TITLE 24, PART 6

Nonresidential Fenestration

Codes and Standards Enhancement (CASE) Proposal

Jeremy Wojtak
September 30, 2025

SECTION 140.3 – PRESCRIPTIVE REQUIREMENTS FOR BUILDING ENVELOPES

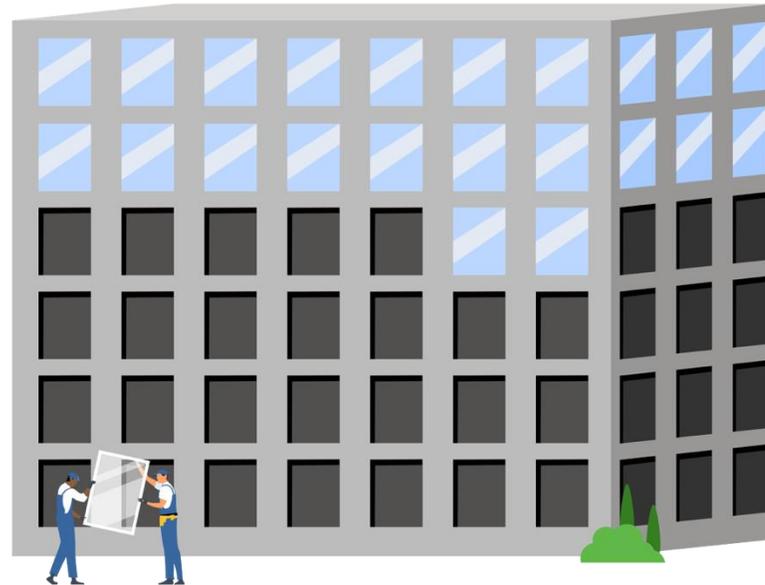
Fenestration – Vertical (Area-Weighted Performance Rating)	CZ 1	CZ 16
Fixed Window (Max U-factor)	0.36 <u>0.32</u>	0.36 <u>0.34</u>
Fixed Window (Max RSHGC)	0.25	0.25
Operable Window (Max U-Factor)	0.46 <u>0.39</u>	0.46 <u>0.43</u>
Operable Window (Max RSHGC)	0.25	0.25

Note that Max RSHCG is unchanged
